## ADDENDUM REPORT

Panel Reference	PPSSEC-36
DA Number	DA-125/2012/C
LGA	Waverley Council
Proposed Development	Section 4.55(2) modification to roof design, ground floor entry, façade stairwell, and increase in height, extension of basement parking and penthouse reconfiguration.
Street Address	20 Illawong Avenue, Tamarama
Applicant/Owner	Proprietors of Strata Plan 1731
Report prepared by	Kylie Lucas, Senior Development Assessment Planner, Waverley Council
Addendum to Report date	25 August 2020

**Figure 1:** Extract from approved plans

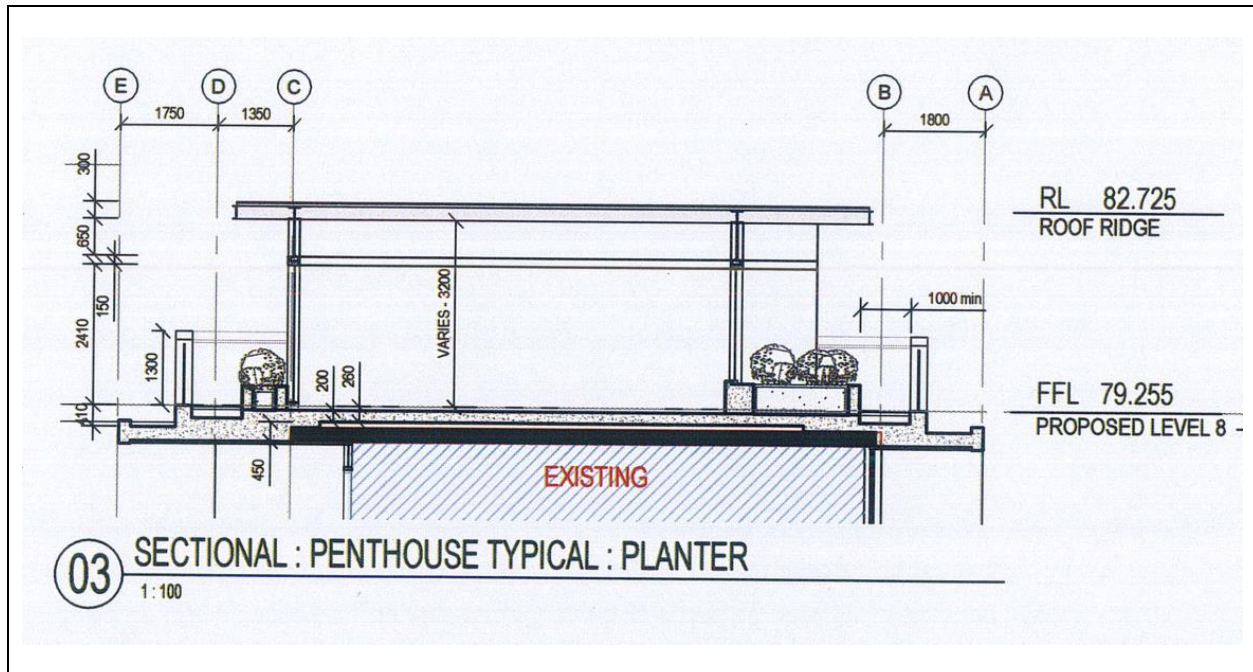
The penthouse apartments are already excessively large with more than double the minimum required floor space for a unit of this type and provide sufficient height to satisfy the Apartment Design Guide of SEPP 65. The original plans approved under DA-125/2012 show a domed roof with floor-to-ceiling height ranging from 2.41m at the lowest point to 3.2m at the highest part of the dome (refer to Figure 1).

The Building Code of Australia (BCA) requires a ceiling height of 2.4m for at least 2/3 of the room for habitable rooms (or an alternative solution). Lower ceiling heights are allowed for non-habitable rooms (including bathrooms and laundries) under the BCA and the ADG. Raising the slab by 215mm would lower the approved ceiling height of the penthouse apartments to 2.2m at the lowest point and 2.985m at the highest. These ceiling heights continue to comply with the BCA and the ADG. The increased height is not a building requirement under any legislation and given the already significant height of this building, the increase is not warranted.

The approval of the penthouse in the original DA resulted in a building that exceeded the maximum height in WLEP by 186%. The internal amenity for the penthouse was considered satisfactory in this application. There is no proper planning justification that providing greater amenity to the penthouse level is reasonable in circumstances where the building already substantially exceeds the maximum height standard. This would create an undesirable precedent and would not be in the public interest.

The justification now put forward by the applicant to increase the height is not supported.
